Office Action Summary

10/500,583

WEBJORN, JAN

DETAILED ACTION

2,940,779

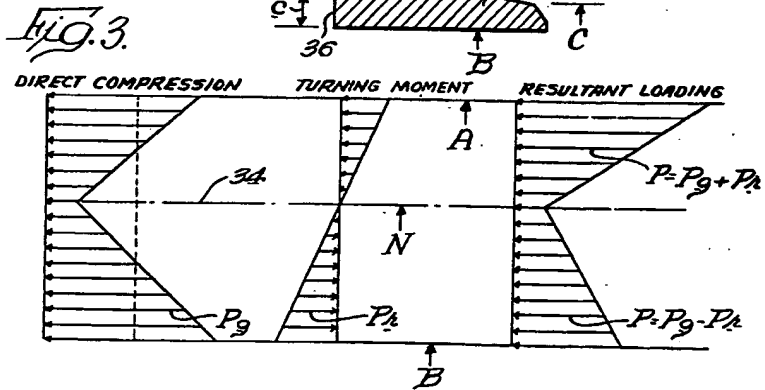
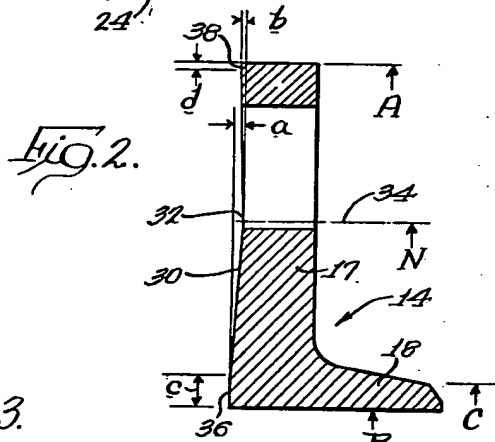
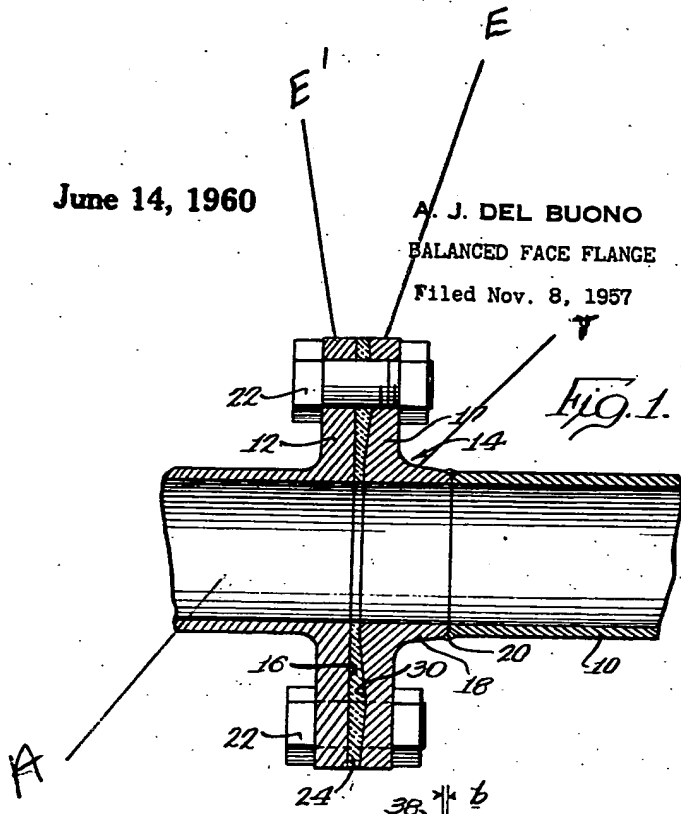
In regard to claim 1: Buono discloses a flanged member (14) (Figs. 1-3) intended to included as a first component in a flange comprising a first component (14) in a flanged joint having a first flanged end (E) with a first end surface (30) intended to be assembled together with a corresponding end surface (16) of a flanged end (E') (see attachment) on another, a second flanged member (12) in the flanged joint, the first end surface (30), in unstressed condition is slightly concave in the radial direction over at least a part of the extension thereof in the radial direction.

In regard to claim 2: Buono discloses (Figs. 1-3) wherein the first end surface (30) is concave over the entire extension thereof in the radial direction.

In regard to claim 6: Buono discloses (Figs. 1-3) that further comprising an internal through axial opening (A) (see attachment), the first end surfaces (30) having an innermost abutment point against the corresponding end surface (16) of the second flanged member (12), which abutment point is situated farthest in the radial direction at the opening (A), the concavity of the first end surface (30) extending all the way in to the abutment point.

In regard to claim 9: Buono discloses (Fig. 2) wherein the first end surface (30) is inclined in the radial direction out-wards and away from a conceived opposite end surface (16).

In regard to claim 10: Buono discloses (Fig. 1) wherein at least a part of a transition area (T) (see attachment), between the surface of the flange directed away from the end surface (30) and a part of the flanged member that is substantially parallel to a longitudinal axis of the member, is shaped as a substantially elliptical area.

In regard to claim 11: Buono discloses a Joint (Figs. 1-3) comprising two joint halves formed as two flanged members (12, 14) and included in a pressure equipment device, the members (12, 14) have at least one flanged end (E, E') each having an end surface (30, 16), and the flanged members (12, 14) are assembled together via the end surfaces (16, 30) of the flanged ends (E, E'), the end surfaces (16, 30) are facing each other, the end surface (30) of at least one of the flanged members (14) being slightly concave in a radial direction over at least a part of an extension thereof in the radial direction when the end surface is in an unstressed condition.
